Review of July 31 2018 City Administrative Report
Re: Parker Lands Major Redevelopment Site Secondary Plan (First Reading)

Public Service Response to 'Review of July 31, 2018 City Administrative Report – Re: Parker Lands Major Redevelopment Site Secondary Plan (First Reading)'

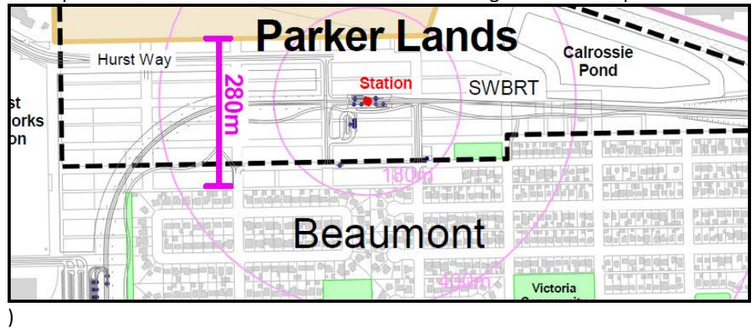
**(B)** The limitations of the site have made it important to address maximum density in the Secondary Plan. We will gladly have the plan impose minimum densities. In order to do this the secondary plan will need to be altered to have at least three (3) neighbourhood policy areas. The Report suggests this. The Public Service will work with the proponent to identify appropriate minimum densities for each policy area.
"Neighbourhood development south of the proposed 'Urban Neighbourhood Policy Area' is limited by a significant hydro-electric corridor. In addition, the alignment of Hurst Way and the SWBRT just north of the 'Urban Neighbourhood Policy Area' act as barriers to direct pedestrian access to the Beaumont Neighbourhood."	**(A)** This concern as expressed by the City Planner was never discussed with the Applicant's planning consultants at any point in the 5 years of discussion with the city. The OurWinnipeg designation process and the planning for the SWRT corridor were purposeful and mindful of the hydro corridor and in fact, formed part of the reason to designate the Parker Lands as an MRS and route SWRTC through the area. The SWRTC runs through the Hydro Corridor. The MRS and SWRTC address and relieve barriers as described by the City Planner. **(B)** This assertion ignores that if cars can travel through the hydro-electric corridor and the SWBRT, then people can cross as well. If that were not the case, no one from the Beaumont neighbourhood would be able to access the new BRT Station - which is located on the opposite side of the above mentioned so-called 'barriers'. This assertion also is not consistent with the City's decision to locate the Parker Rapid Transit Station in an area that is accessible to surrounding communities. The design of the new Rapid Transit Corridor provides for new Active Transportation paths (walking paths and bike lanes) east of the Kiss-and-Ride connecting the Beaumont community to the Transit Station and from the future station plaza northwards, to the Urban Neighbourhood Policy Area. **(C)** It should be noted that the distance shown on Figure 7 – Distance to Beaumont Neighbourhood from the Planning Report (between the south end of the Neighbourhood Policy Area and the north end of Beaumont), is shown as 280m which translates to approximately a 3-minute walk. To access the nearest school, community centre, etc. is a few minutes away which is not an unreasonable assumption to make. **(D)** The distance from the Parker Rapid Transit Station to the potential highest density area of the Urban Neighbourhood Policy Area is less than 180m away, or about a 2-minute walk.	**(A)** Proximity to the Beaumont Neighbourhood was never an issue to consider until Urban Neighbourhood TOD was unexpectedly included in the Secondary Plan submitted by the proponent. **(B)** It is true that vehicles may easily pass through the Hydro Corridor and across the SWBRT roadway via the collector road. However, this does not make the Beaumont neighbourhood pedestrian accessible (within 400m) from the Fulton Grove development. It is assumed that pedestrians will not be allowed walk on the SWBRT, other than at controlled locations. The Station IS accessible to Beaumont Neighbourhood. However, Fulton Grove is NOT. Accessing Fulton Grove will require walking along the collector road to cross the BRT line. The reason this is even a topical issue is because 'accessibility of the TOD from adjacent neighbourhoods' is a TOD typology consideration. **(C)** The report also indicates that the SWBRT line runs through this 280m separation area.
